AMENDMENTS TO THE DRAWINGS:

REMARKS/ARGUMENT

FIG. 1
(PRIOR ART)

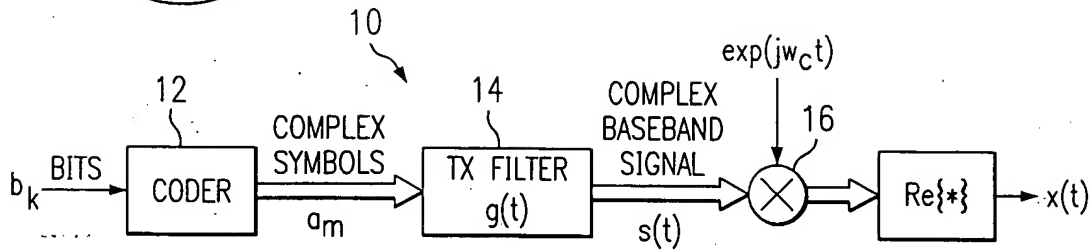
Responsive to the Examiner's requirement that Figures 1-4b should be designated by a legend such as --Prior Art--, corrected drawings in compliance with 37 CFR 1.121(d) are submitted herewith.

Regarding Figure 1, Applicants propose changing the identifier "100" to instead be "101" so as to avoid confusion.

FIG. 15

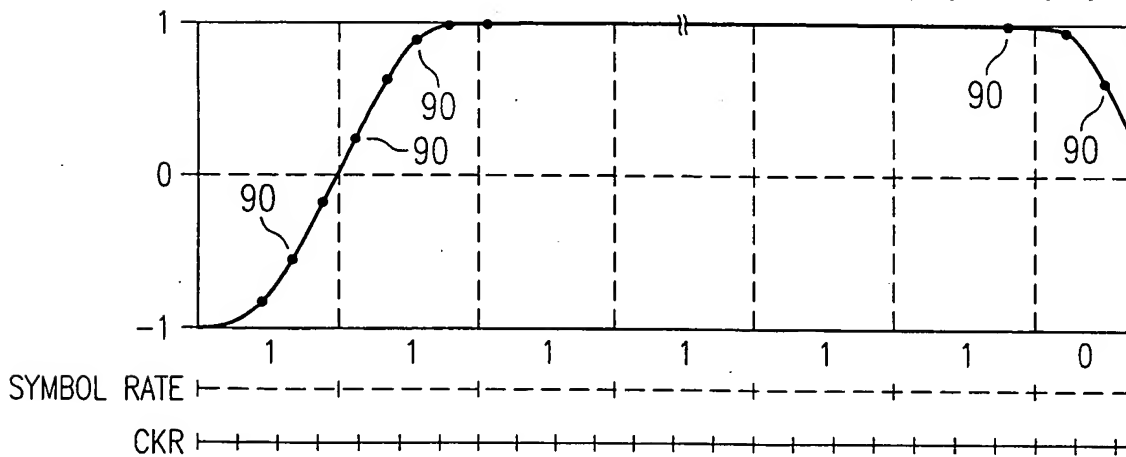
Responsive to the Examiner's determination that the drawings fail to comply with 37 CFR 1.84(p)(4), Applicants propose amending drawing Figures 15, as set forth below.
